THE STANDARD AT SEATTLE - THE TOWERS

RECOMMENDATION MEETING #2

DPD PROJECT #: 3033094

SUBMITTAL DATE: AUGUST 14, 2020

DEPARTURE 1 - MAXIMUM WIDTH AND DEPTH LIMITS

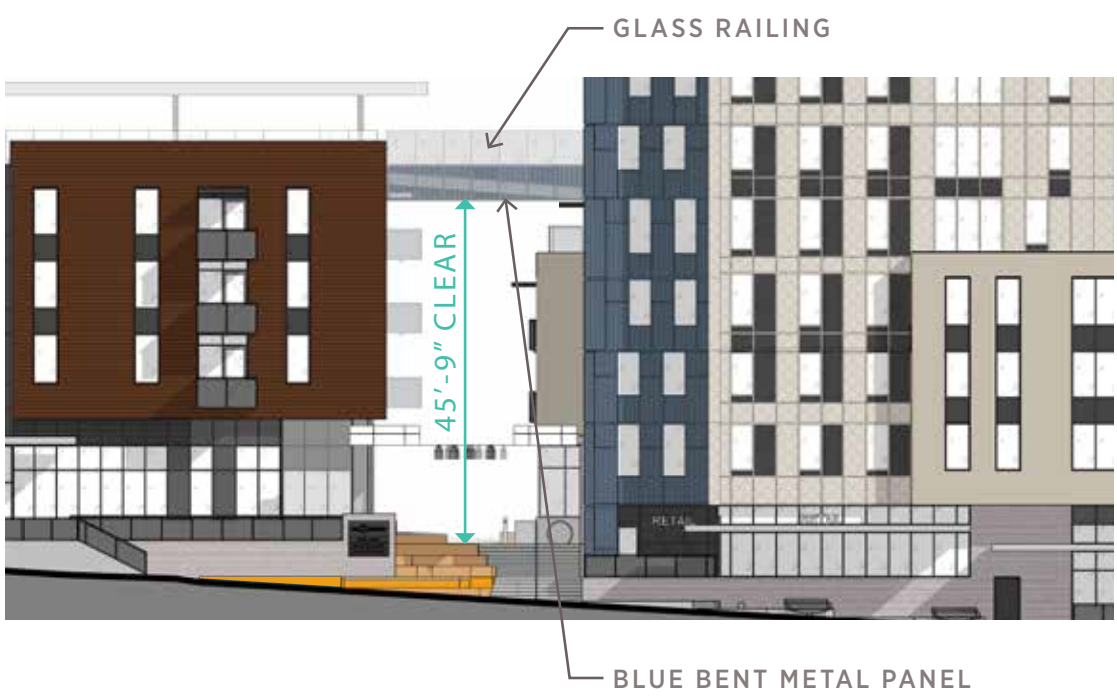
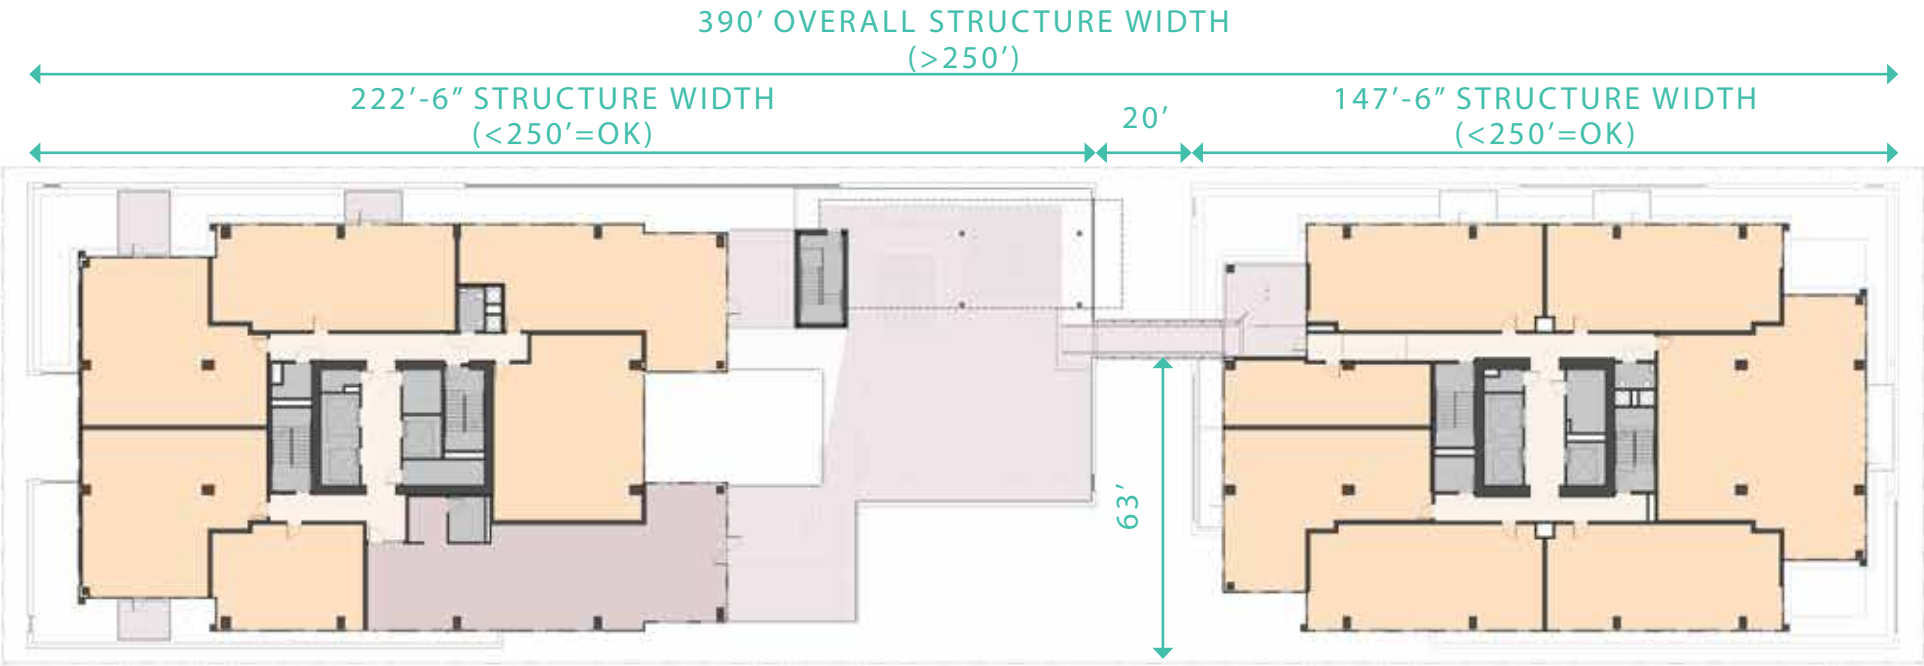
EDG COMMENT

The bridge element is seen as an integral part of the overall parti diagram. It becomes the last vestige of connection between the two parts of the project which used to be one form. The bottom of the bridge is clad in the same system that makes up the blue muscle material, while the top is made up of a glass railing tying in with the 5'-0" high protective glass railing around the exterior fifth floor amenity deck. This continues the relationship consistent with the overall language seen between the two towers.

SOUTH TOWER
ROOF OUTLINE 10,615 SF
COMBINED AMENITY/MECH. 5,701 SF
53.7% COVERAGE < 65% = **COMPLIANT**

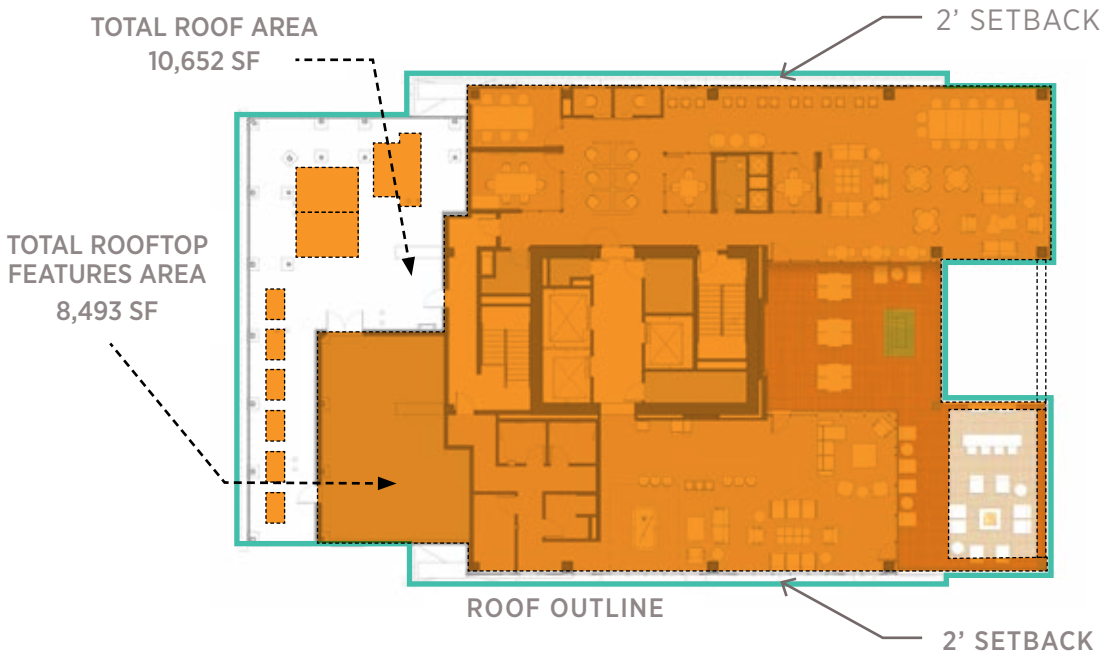
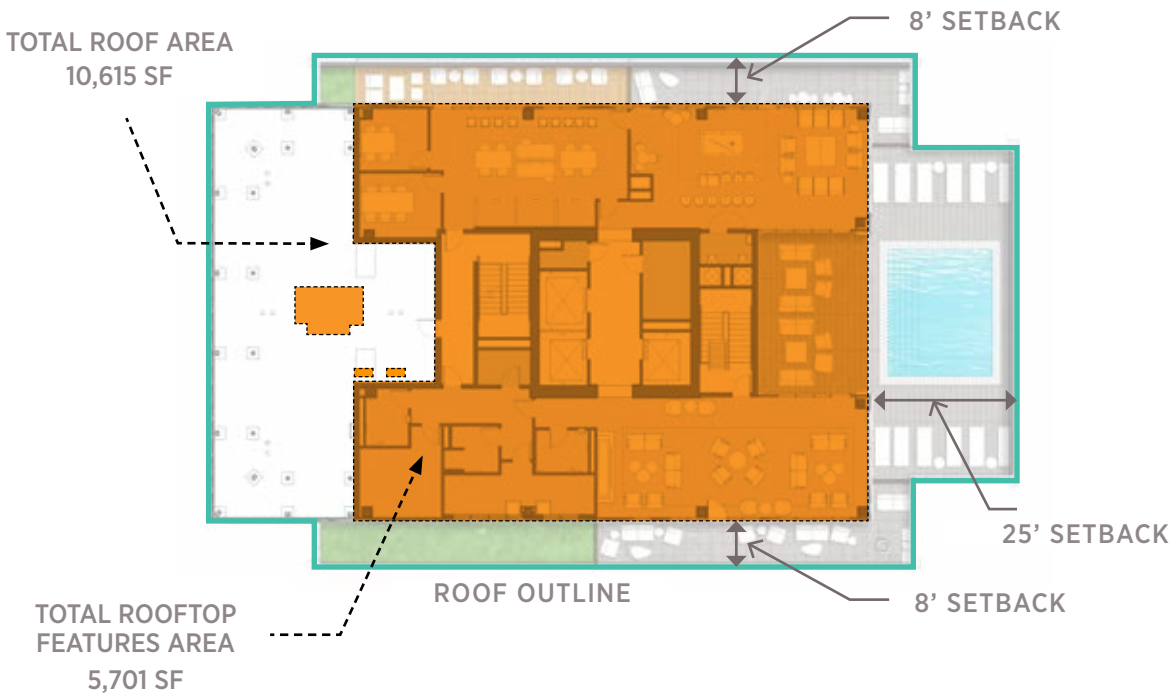
The Board indicated the possibility of supporting this departure if the non-code-compliant elements were integrated into the larger architectural concept and if departure were part of an assembly that would yield the bold, sculptural form identified in the preceding guidance at 1.e and 1.f, above (DC2, DC2-6-j)

To allow the guardrails at levels 25 on both the north and south towers to be 5'-0" tall in order to provide the WAC required guardrails for pools and hot tubs, and to provide general safety for residents at these higher levels.

In an effort to have a consistent design language, and to also provide a higher level of safety for residents, the 5'-0" guardrail is proposed around all upper outdoor deck areas whether they are adjacent to a hot tub or pool, or not.
